Initial Project Review

Rear Yard Setback Variance: Fortino-Chavez

Application Number: 1019051

Proposal: Land Use Variance to setback requirements for construction of a new attached garage with an ADU (Accessory Dwelling Unit) constructed above the garage. Proposed reduction of setbacks would be to reduce the rear yard setback, as measured from the rear property line to 4 feet, as opposed to the 10-foot rear yard setback required in Single Family (SF) zoning.

Figure 2: Site Plan

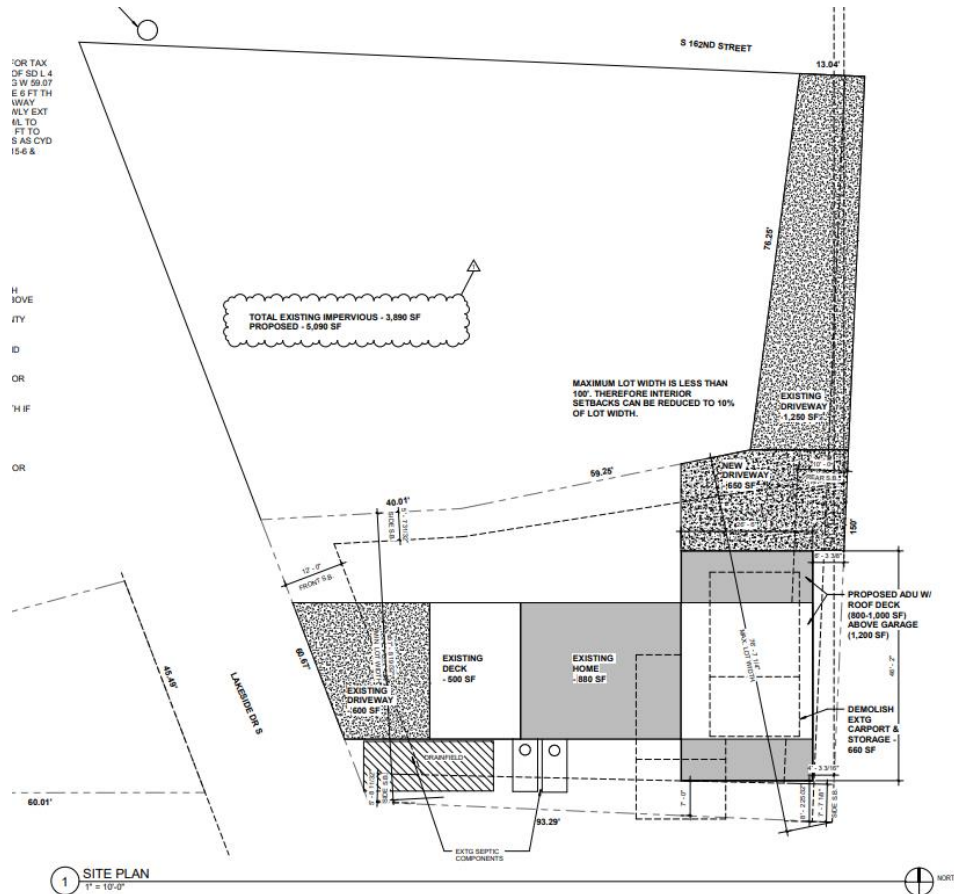
Staff Comment: The proposed setback of 4 feet from rear yard setback will require a Variance to the 10-foot required rear yard setbacks from the rear property line.

Eaves are allowed to project up to two feet into a required setback. They may not, however, project into a setback altered by a Variance unless the Variance specifically allows for this added projection. The proposed site plan shows the structure and does not show the eaves going 2 feet past the proposed setback.
